Pamban Lighthouse

Marine endorsement on Presidency Port officer's letter for the preparation of revised estimate in accordance with Mr. Ashpitel's design for alterations to the —, communicated to Superintending Engineer, VI Circle.

Submitting copy of
letter from the Ex. Engrs.
Madura Div: suggesting
certain alterations in
the sanctioned plan
for the Light house at
Pamban.

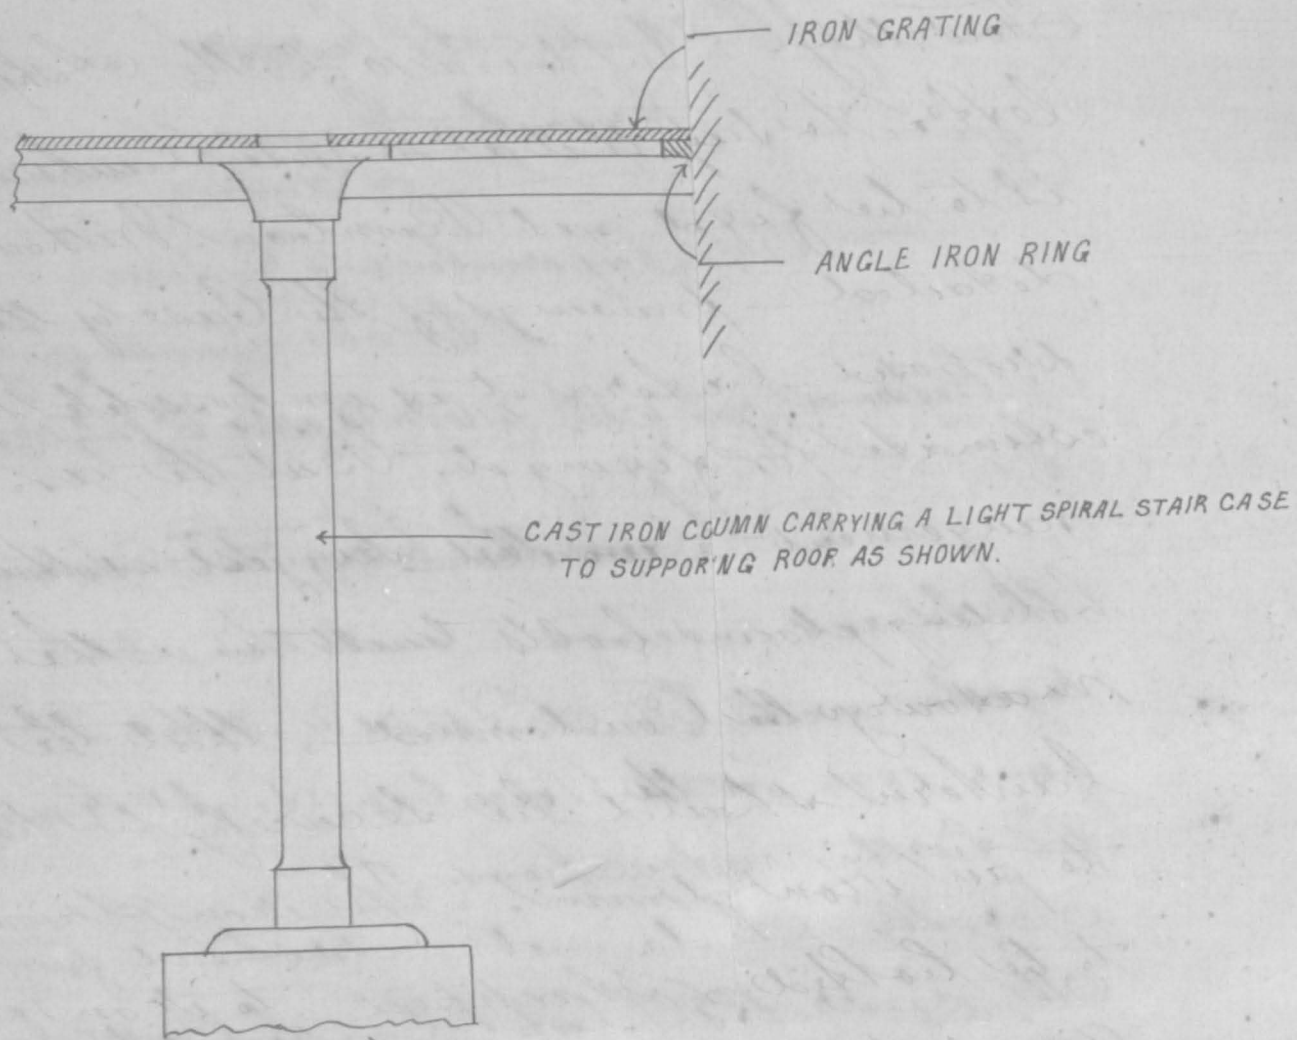
Firstly. I do not understand from
Mr. Garrett's Plan how the Cast Iron
Pillar is fixed to the "iron Ring". I
cannot find any accurate or
large scaled drawing of the
pillar. The whole arrangement
seems to me unnecessarily expensive.

Secondly. I do not understand
the Cement Concrete floor nor the
pillar below it with the Giddap-
pah Slabs.

A light spiral staircase
supporting a light iron floor
would be cheaper and less
troublesome

troublesome to build.
See Sketch in margin.

Thirdly. The arrangement for fixing the lantern to the masonry is not shown. Holding down bolts would shake a foot wall, even if built of masonry in cement, to pieces. The 1 foot wall on top also takes up a great deal of room. An iron drum is all that is required (See plan of Star Island Light House enclosed). Such a drum could easily be bolted firmly down to the solid masonry of the light house. The action of the wind on the lantern must

Firstly - As I have not seen a drawing of the pillar
which carries the apparatus I cannot say how it
should be fixed to the ring but I imagine that there
will be no difficulty - The arrangement of the girders
carrying the light room floor is the ordinary plan
adopted by Trinity House and I do not think that
it is unnecessarily expensive - The ring should be
designed with reference to the base of the existing
column.

to give sufficient headway. There is no particular reason why any other form of fire proof floor should not be constructed if preferred. Buddapak slabs were shown in the plan as being a convenient material to use but there is no objection to any other equally suitable material being substituted. The sketch given by the Executive Engineer is inaccurate as the iron grating should form the light room floor which should not be supported as shown. ~~It~~ occupy the centre of the proposed service room with an iron column and spiral staircase would to a large extent, render it useless for the purposes for which it is required.

Thirdly - No doubt an iron pedestal would be far superior to the proposed masonry lantern base and is the usual type of lantern pedestal at all new stations. The existing lantern at Panthen is, however, reported to be very old and not worth the comparatively large expenditure required for an iron pedestal. Masonry pedestals have been provided at many stations and the thickness of one foot is slightly in excess of the standard dimension. The weight of the lantern is probably about 1400 lbs and I do not think the action of the wind would have the effect anticipated by the Executive Engineer. There is no objection to the substitution of an iron pedestal if the cost is not prohibitive and provided that the lantern, which is obsolete in form, is

Fourthly - On further enquiry it is reported that the lantern said to be available is of the 5th Order. It is therefore no larger than the existing lantern and the proposed transfer is unnecessary. Detailed drawings of the base of the existing lantern do not appear to be available, but there will probably be no difficulty in refixing it in the same way as before.
